Weston & Sampson

August 30, 2018

Re: Review of Remediation Activities at 17 Lawrence Street, Norfolk, MA (RTN 2-3000173)

FIGURE 9

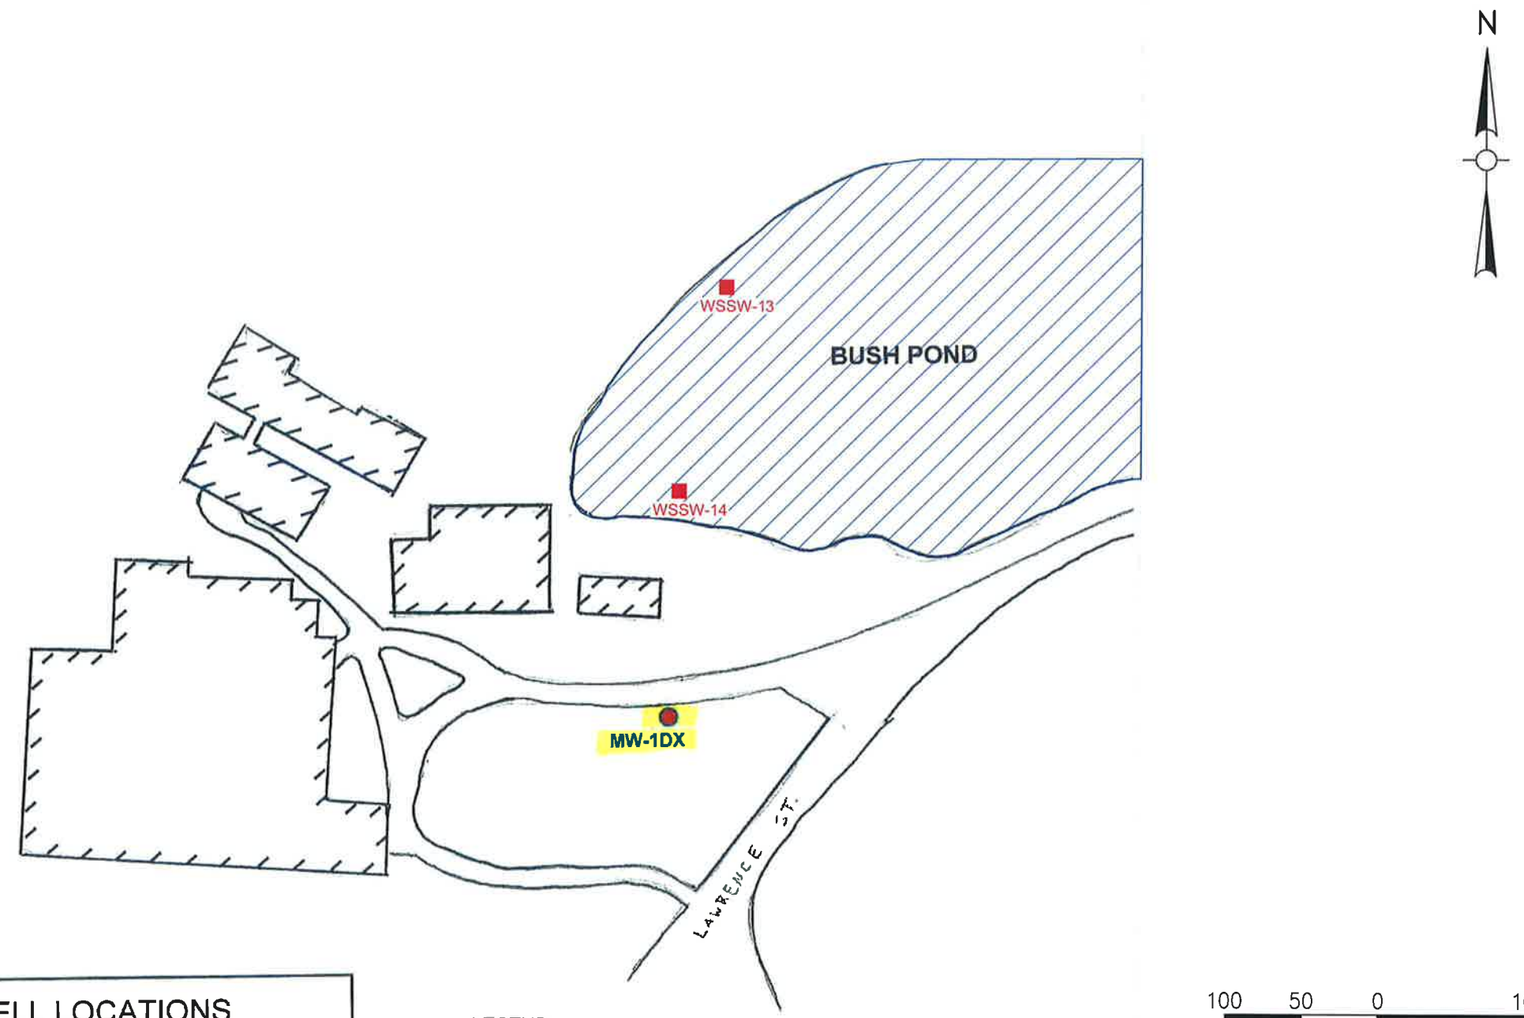
Arsenic was detected in seven of the nine wells at concentrations above Method 1 GW-1 standards, including wells WS-3 and MW-3DX. Except for low level detections of barium and zinc below relevant Method 1 Standards, no additional metals were detected in the analyzed samples. Trichloroethylene (TCE) was the only detection of VOCs from monitoring well MW-3. No previous detections of TCE had been reported at the site, and the source of this detection is unknown. As TCE was detected at 3.02 ug/L vs. a Method 1 GW-1 standard of 5 ug/L, Weston & Sampson recommends additional VOC delineation in this area to assess whether this detection was anomalous, or whether further assessment is needed both spatially and at deeper depths in the aquifer.

To support a Stage II Environmental Screening, additional sampling of Site sediment, surface water and / or soils will likely be required. Considering concerns raised by the Conservation Commission pertaining to potential impacts to Bush Pond, and in consideration of potential outlet structures to this surface water body from the Buckley and Mann Site, sampling of surface waters and sediment within the pond is recommended to support the human and ecological risk assessments. Additional sampling of all Site surface water bodies, and associated sediments is also recommended to further assess environmental risks in support of the Stage II Environmental Screening.

From an environmental risk and MCP perspective, Weston & Sampson additionally notes that overall, total arsenic appears to be the primary contaminant identified to date in Site groundwater. Through the various assessments performed by Mabbett, these high arsenic concentrations have been potentially attributed to soil particles remaining within the collected water samples, rather than dissolved arsenic within the groundwater. Further assessment of treatment for, at a minimum, the dissolved arsenic concentrations should be considered during design of treatment systems for any wells installed near the Buckley Mann Site. Additional monitoring well installations between the Buckley Mann Site and the production well location should also be considered to further supplement the existing on-site data.
